WITTENBORG

TECHNICAL INFORMATION

TYPE NO	TYPE	T.I.-NO
FB 2800	**Freshbrew machines with Classic brewer**	**FB. …01/2003**

SUBJECT	ISSUED FOR (X):	
Changed scraper switch	Action	
	Information	X

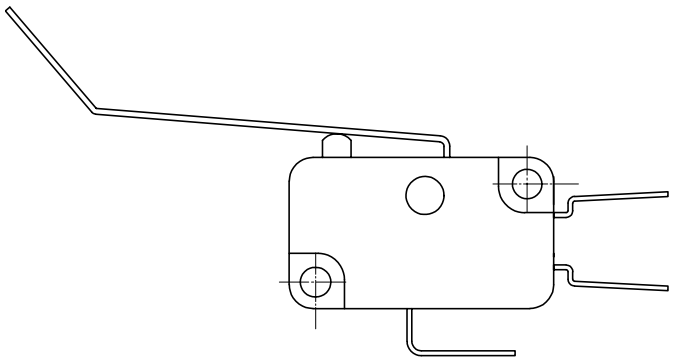
- The design of the switch arm for the scraper switch - part no 29739000 has been modified.

- The switch arm of the scraper switch has been redesigned, as the design of the old switch arm caused start/stop errors on the brewer.

- The changed scraper switch is direct replaceable in all Classic brewers.
